**1. HD 9/20, HD 10/25,
HD 13/18
Piston (4.553-279 /-280 /-282)**

**Service Bulletin
No. 2008-010 dated 06.08.2008
Classification level III**

**1.) HD 10/25 (1.286-xxx)
HD 13/18 (1.292-xxx)****Contactor 6.632-334 / -356
PCB 6.682-653 / -672/-801/-848****Service Bulletin
No. 2006-027 dated 02.08.2006
Classification level III**

**1.) HD 10/25 (1.286-xxx)
HD 13/18 (1.292-xxx)**
**Contactor 6.632-334 / -356
PCB 6.682-653 / -672/-801/-848**
**Service Bulletin
No. 2006-027 dated 02.08.2006
Classification level III**

Fig. 1

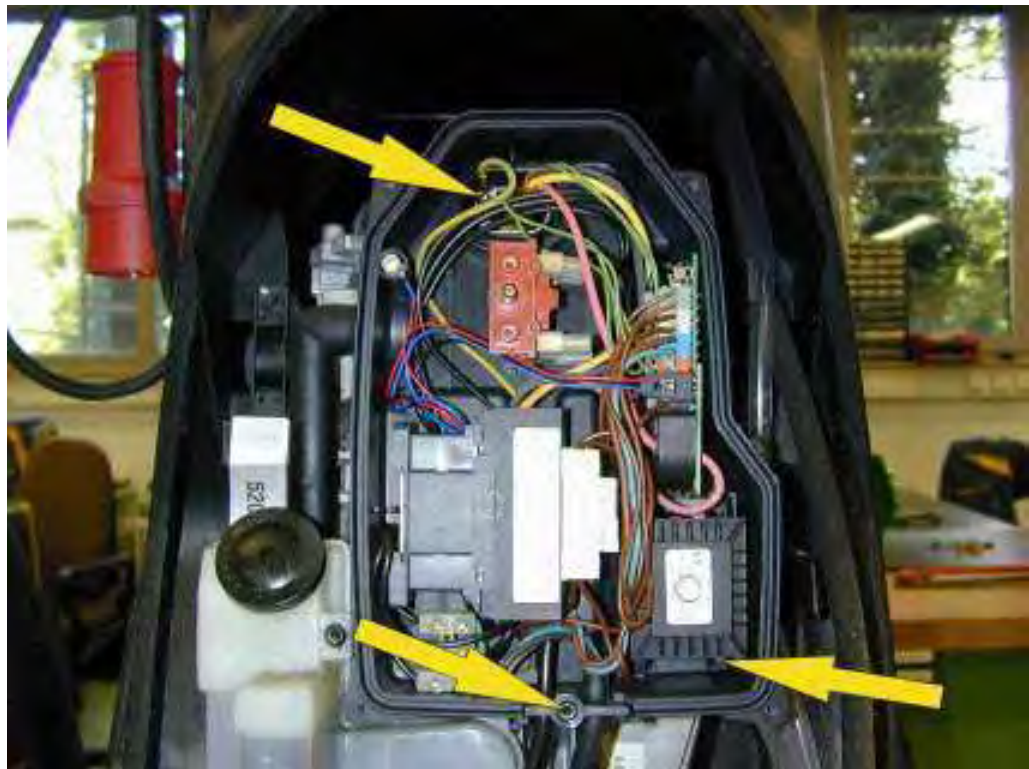
- Switch the unit off and disconnect the mains plug
- Remove the unit cover, remove the electrical box cover
- Remove the marked screws at the electrical box lower part
 1. screw from strain relief
 2. screw from transformer
 3. screw for fastening the earth cable

Fig. 7

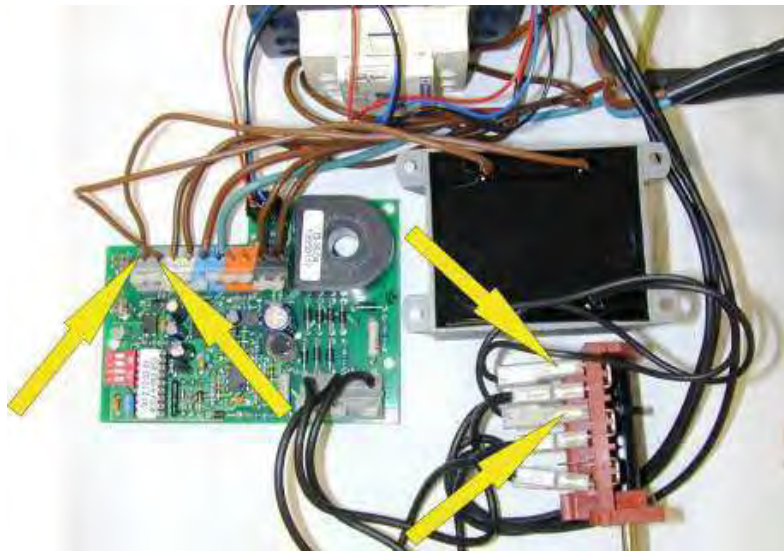
Disconnect the old transformer and connect the new one. There is no terminal configuration for the two brown and two black cables.

Use the screw contained in the set for fastening the new transformer. The new screw 6.303-328 (3x12 mm) is smaller in size than the old screw.

Fig. 9

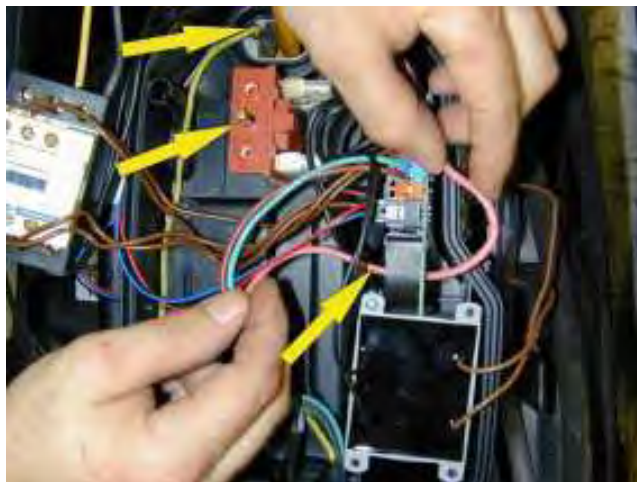
- Fasten the earth cable. Before positioned the unit vertically.
- Fit ON/OFF Switch
- Put pink cable through the PCB

Fig. 11

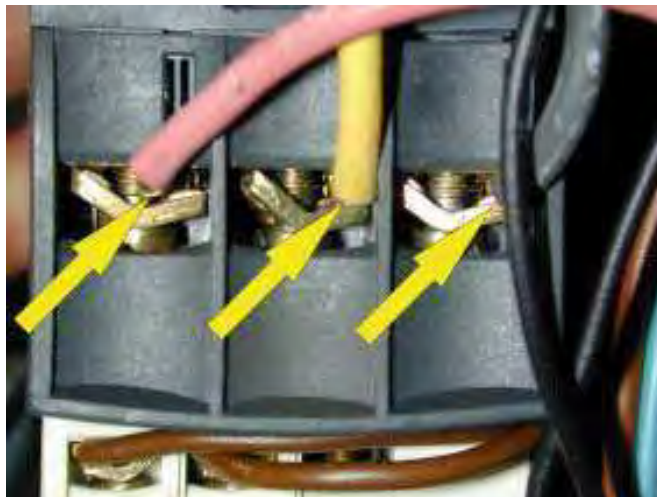
Connect up the contactor again (T3 pink, T2 yellow, T1 black)

Fig. 12

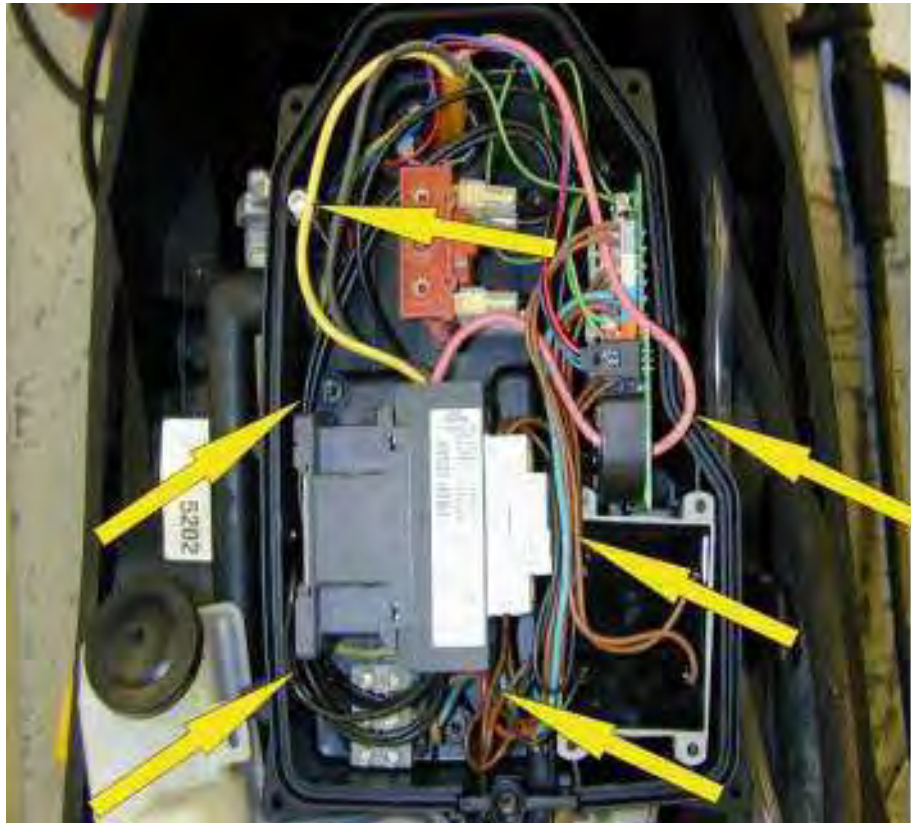
- Fit the contactor in the electrical box lower part. Caution, retainer plates have to be inserted at the corresponding points
- Insert the control lamp
- Wiring as marked
- Caution when fitting the electrical box cover on the electrical box lower part: there is a risk of the (pink) cable getting crushed in the area of the PCB

Make sure that no cable is jammed under the contactor when wiring the cables.
